ISSUE: Permit to Demolish/Capsulate (partial) and Certificate of Appropriateness

for alterations and an addition

APPLICANT: 720 St. Asaph Partners, LLC

720 North Saint Asaph Street

PROPOSED FLOOR PLAN – BASEMENT

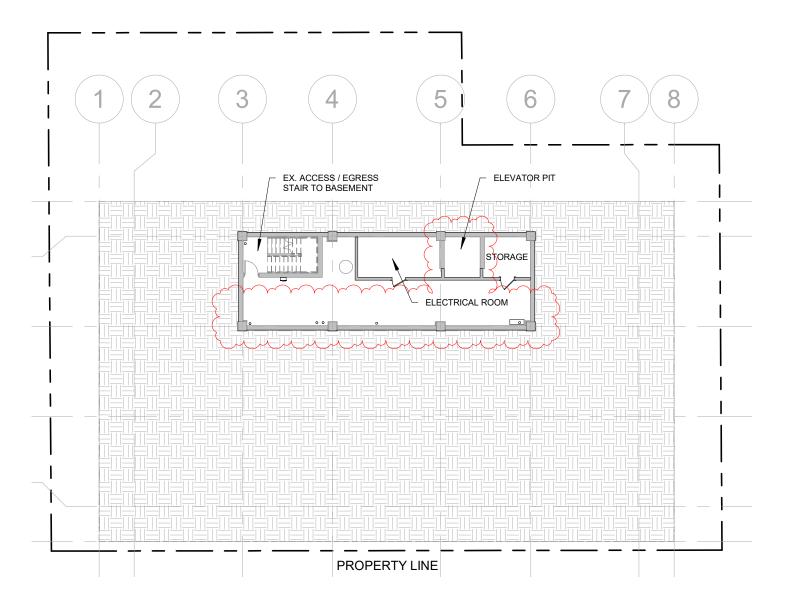
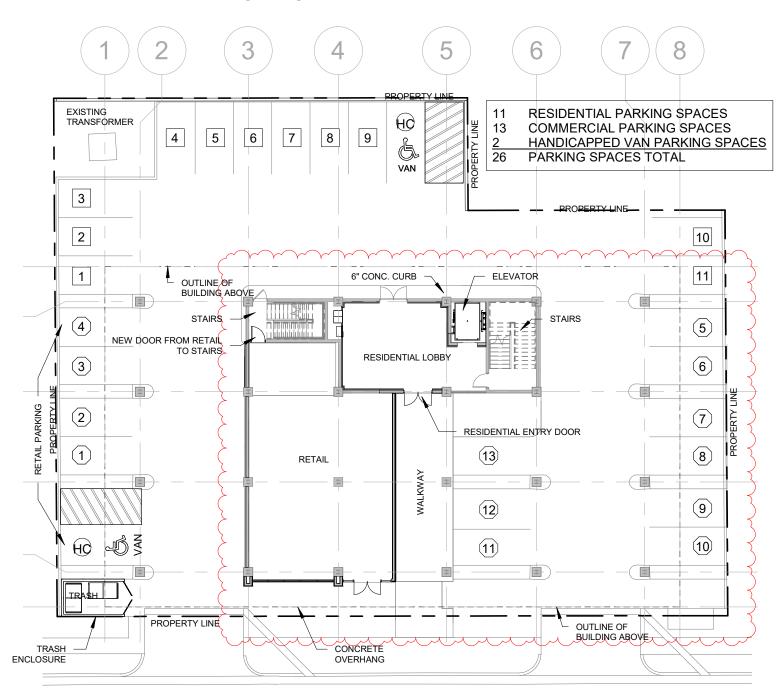
REVISIONS AFTER 04/17/2024 BAR APPROVAL:

- THE ELEVATOR DOESN'T GO DOWN TO THE BASEMENT- ONLY ELEVATOR PIT.
- THE LOCKERS ARE REMOVED.

PROPOSED FLOOR PLAN – GROUND LEVEL

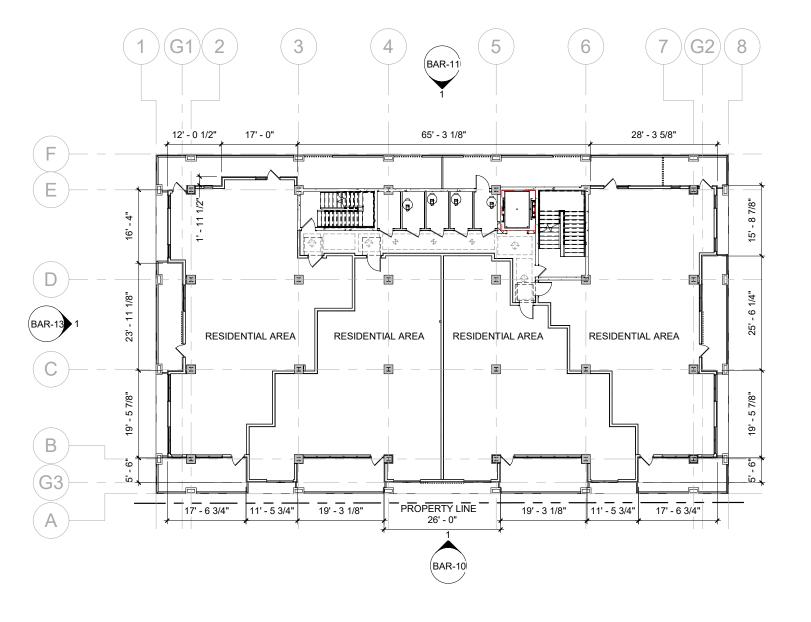
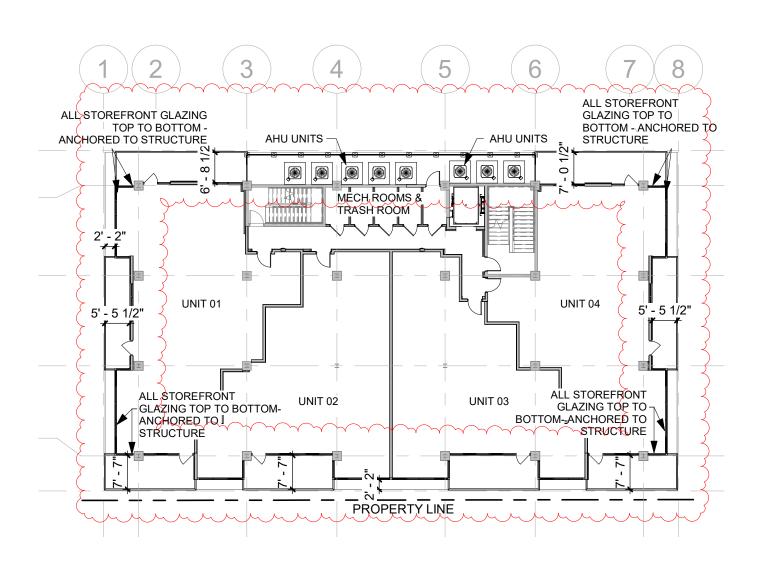
Mr. Scott asked why the retail space on the ground floor was reduced.

Ms. Reilly responded that it was done to retain the existing parking space for residents and retail visitors, making it more marketable to potential retail tenants.

Ms. Del Ninno commented that it would be nice to have more retail space and less parking space along the ground floor frontage. She suggested removing the trash enclosure from the St. Asaph frontage.

REVISIONS AFTER 04/17/2024 BAR APPROVAL:

- SMALLER RETAIL SPACE TO THE WEST SIDE OF THE RESIDENTIAL ENTRANCE.
- SMALLER RESIDENTIAL LOBBY
- **REVISED PARKING SPACE**

Ms. Reilly responded that the City Council-approved special use permit did not require retail space but some is still provided, and that it is being designed to attract retail tenants and will still enliven the pedestrian streetscape. She also said that the trash enclosure has to be in the same location in order to provide parking and utility access.

PROPOSED ELEVATION - EAST

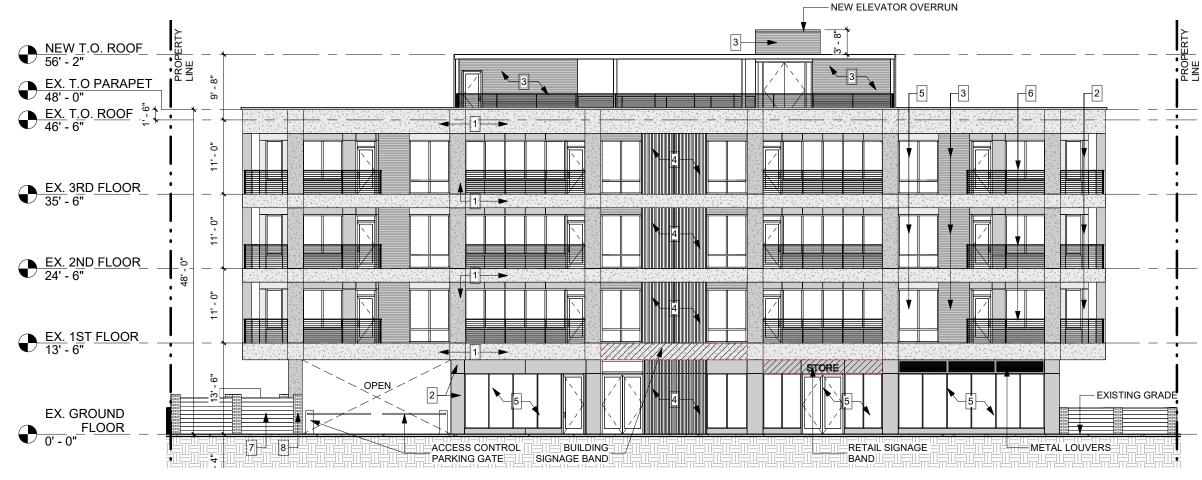
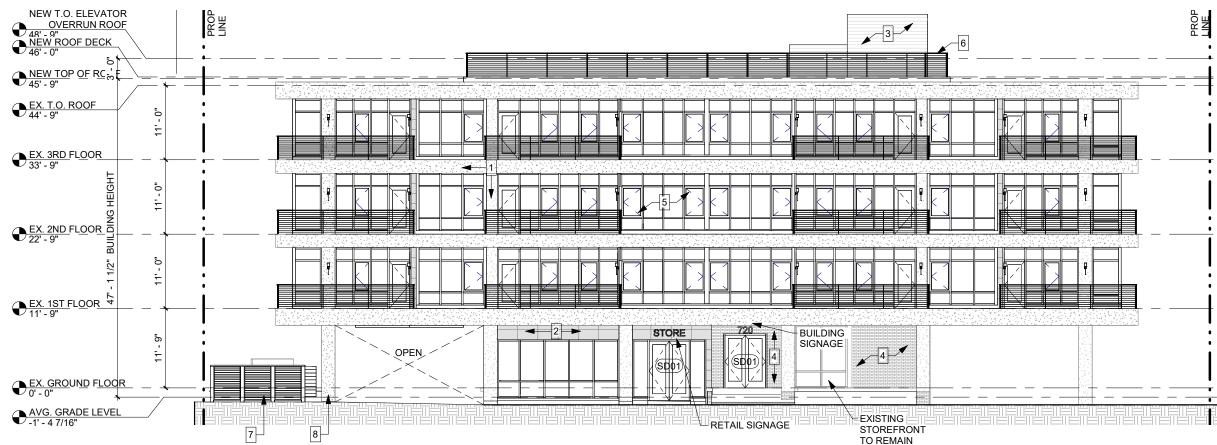
Mr. Adams suggested adding back in some of the vertical elements of the original brutalist design to make the exterior more striking.

Mr. Scott thinks the vertical element that grounded the building in the originally approved design has been lost in the new design. He thinks the ground floor would look better with no retail space than with the reduced retail space to keep the illusion of a floating building. He also has concerns about the asymmetry of the ground floor. He thinks the existing vertical elements such as the decorative piers helped to ground the building and are a distinctive architectural feature of the building.

Ms. Reilly said the design team could work with staff to recall some of the vertical elements, but that the newly proposed design attempts to replicate the symmetry of the vertical elements and brutalist style.

Ms. Crawford said that the team could work with staff to update the design to recall the exterior column locations.
